# Environment and Health Assessment Study for the Hot Blend Asphalt Plant (HBAP) in Birzeit Town<sup>1</sup> Prepared by Birzeit University

An academic committee formed by Birzeit University's President and approved by Birzeit Municipality prepared this analytical study. The objective of this study was to assess the health and environmental impacts of the establishment of the Hot Blend Asphalt Plant (HBAP) in the industrial area of Birzeit Town. The study included: a critical review and analysis of the Environmental Impact Assessment (EIA) study provided by the owner (Appendix 1), the compilation of information and evidence from the academic literature, an evaluation of local, regional and international experience on the subject, and the application of a computer model for air pollution dispersion. In addition, the committee conducted a field visit to the area where the HBAP is under construction.

# 2. Review of the EIA study (Appendix 1) submitted by the owner of the HBAP, revealed the following serious shortcomings:

## Appendix 1: A critical review of the EIA study report

Appendix 2: Result of model simulation on air pollutants dispersion using the US EPA SCREEN V.4 software.

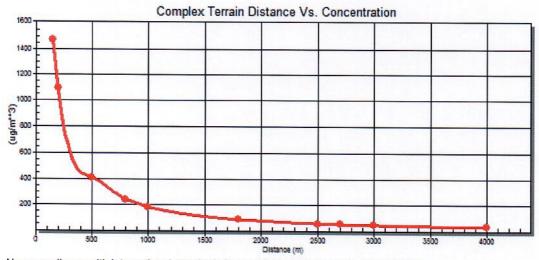
Non-compliance with international standards by a setback distance up to about 3.60 km

Note: It is assumed that the HBAP complies with annual pollution loads of 100 tons per years [US EPA 2002]
